**Wichita-Sedgwick County  
Metropolitan Area  
Planning Department**

**Re:** **BZA2024-00065:** Administrative Adjustment in the City to reduce the street side setback from 15 feet to 12 feet (20 percent) to construct a single-family dwelling on property zoned SF-5 Single-Family Residential District, generally located within one-half mile east of South Seneca Street and within one-half mile north of West 47<sup>th</sup> Street South (4502 S. Sycamore).

Site Plan — Administrative Adjustment  
 4502 S. Sycamore  
 House Plan: The Angel  
 Lot 1, Blk 13, Purcell's 10th  
 Builder: Titan Builders, LLC  
 Angel Moreno

**SITE PLAN**

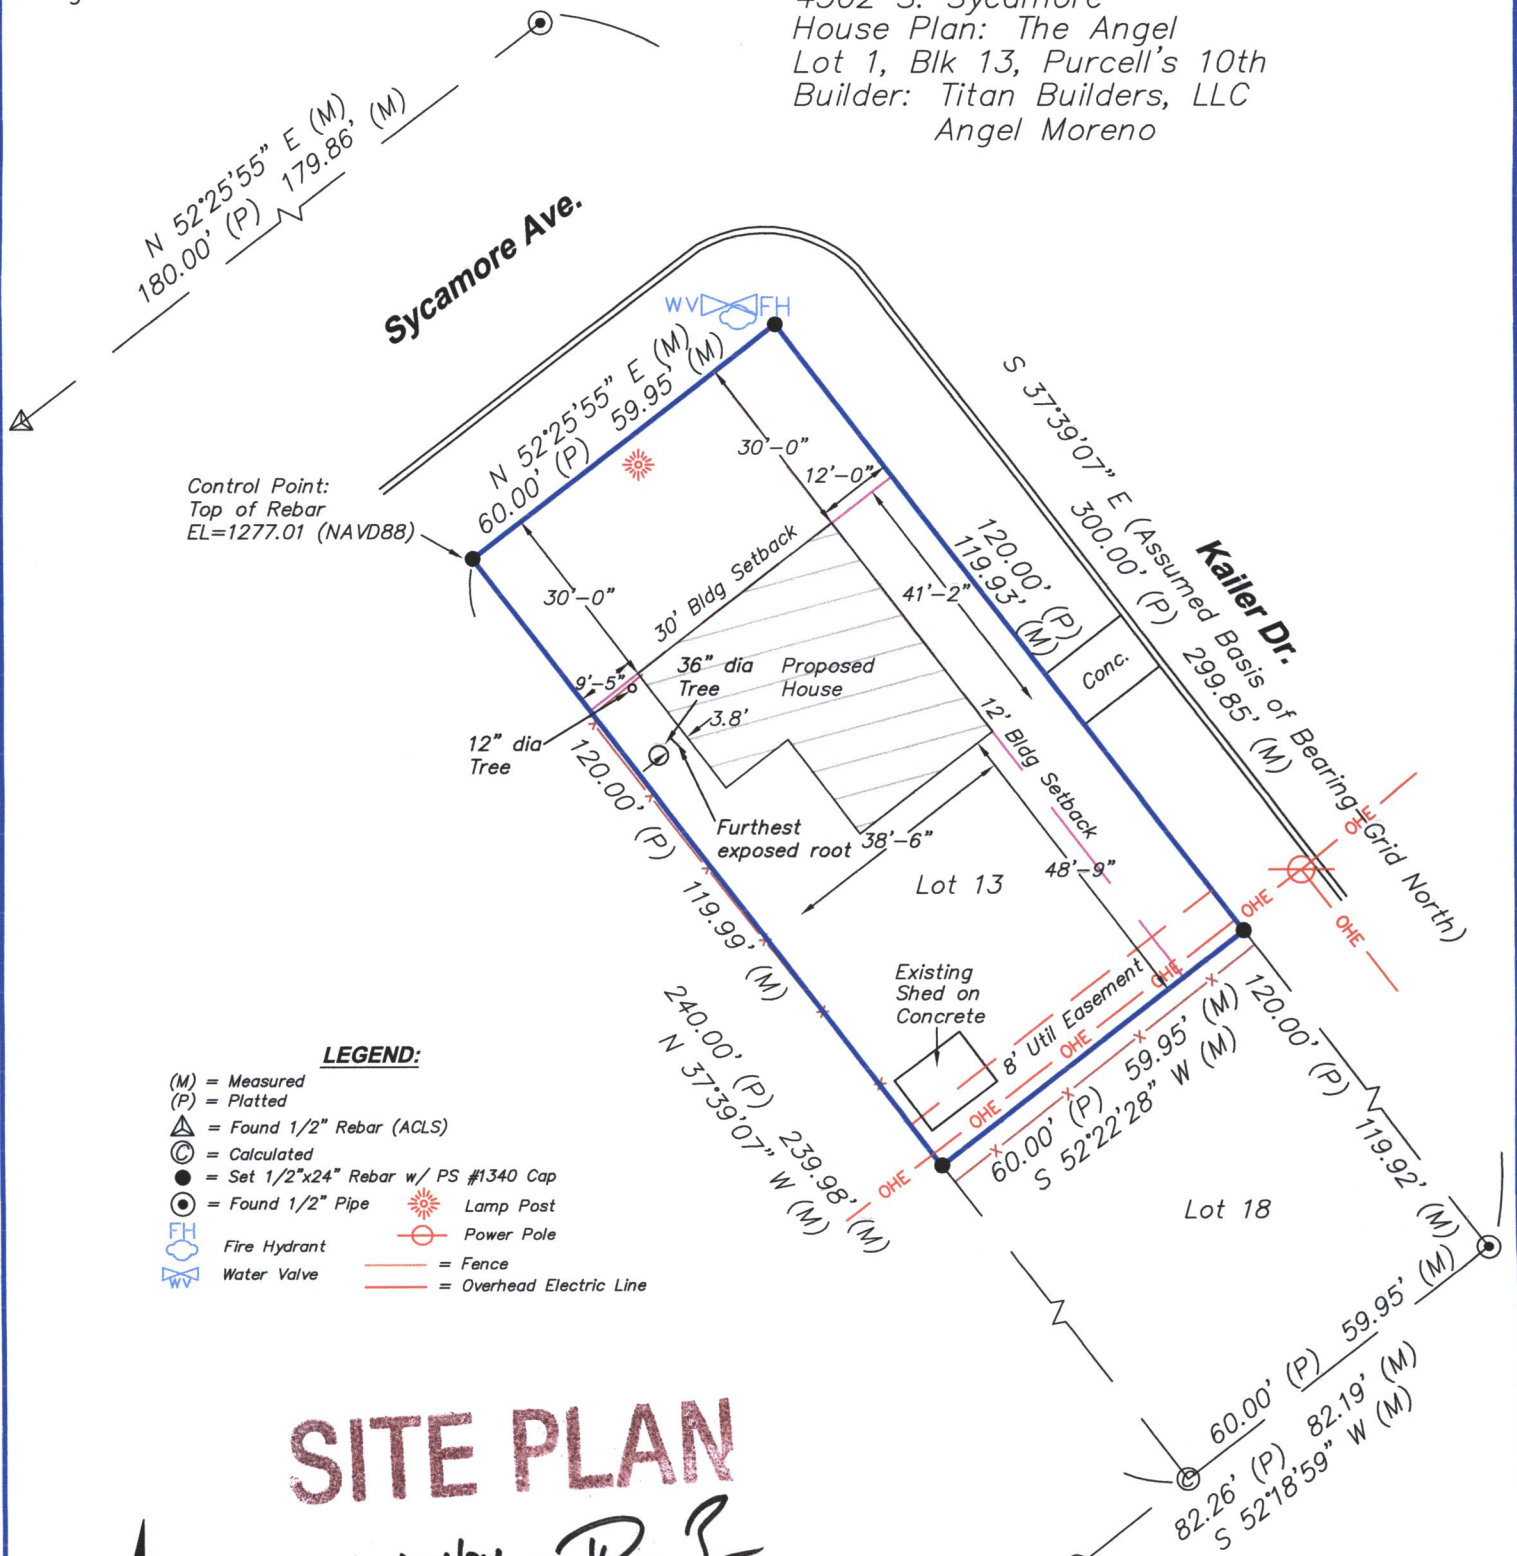
- 1) The existing shed that is shown to be encroaching into the 8-foot utility easement shall be relocated out of the utility easement, and the site plan shall be revised accordingly, prior to the issuance of building permits.

- 4) The setback reduction shall apply only to the 12-foot street side setback for a dwelling as illustrated on the approved site plan. All other structures or additions on the subject properties shall conform to the setbacks permitted by the Unified Zoning Code unless a separate Zoning Adjustment or Variance is granted.
